Access Compliance Report

Public Rights-of-Way

(Curb Ramps)

Intersection ID: 1003360	Main Street: HEATHCOTT_CR	Cross Street: N/A	Location: NE
ADA ID: A20EA3CB29B1	Ramp Type: Perp	Initial Pass/Fail: Fail	Overall Compliance: No
Codes/Mitigation Info/Possible Solution		Field Measurements/Component Compliance

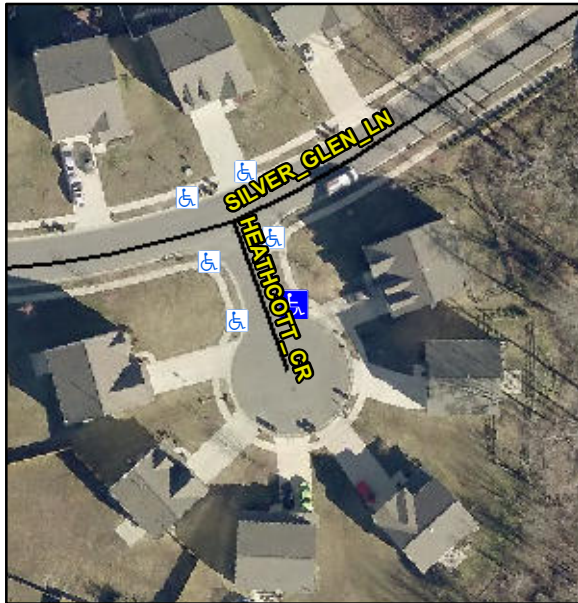
Not Found, R304.5.1

Compliance	Description	Data	Compliance	Description	Data
N/A	Ramp Length (in)	48.0	Yes	Ramp Slope (%)	7.3
No	Ramp Width (in)	47.0	Yes	Ramp XSlope (%)	2.9
N/A	Flare Type LT	N/A	N/A	Flare Type RT	N/A
N/A	Flare Slope LT (%)	N/A	N/A	Flare Slope RT (%)	N/A
N/A	Flare Traversable LT?	N/A	N/A	Flare Traversable RT?	N/A
N/A	Landing Length (in)	N/A	N/A	DWS Provided?	N/A
N/A	Landing Width (in)	N/A	N/A	DWS Contrast?	N/A
N/A	Landing Slope (%)	N/A	N/A	DWS Length (in)	N/A
N/A	Landing X Slope (%)	N/A	N/A	DWS Full Width?	N/A
N/A	Landing Curb? (Y/N)	N/A	N/A	DWS Offset (in)	N/A
N/A	Shared Landing?	N/A			
N/A	Gutter Ponding?	N/A	N/A	Gutter Slope (%)	N/A
N/A	Gutter Lip Ht (in)	N/A	N/A	Gutter X Slope (%)	N/A
N/A	Painted X Walk1?	No	N/A	Painted X Walk2?	N/A
	X Walk 1 Direction	To W		X Walk 2 Direction	N/A
N/A	X Walk 1 Width (in)	N/A	N/A	X Walk 2 Width (in)	N/A
	X Walk 1 Slope (%)	2.1		X Walk 2 Slope (%)	N/A
	X Walk 1 X Slope (%)	3.5		X Walk 2 X Slope (%)	N/A

Remove & Replace Entire Ramp.
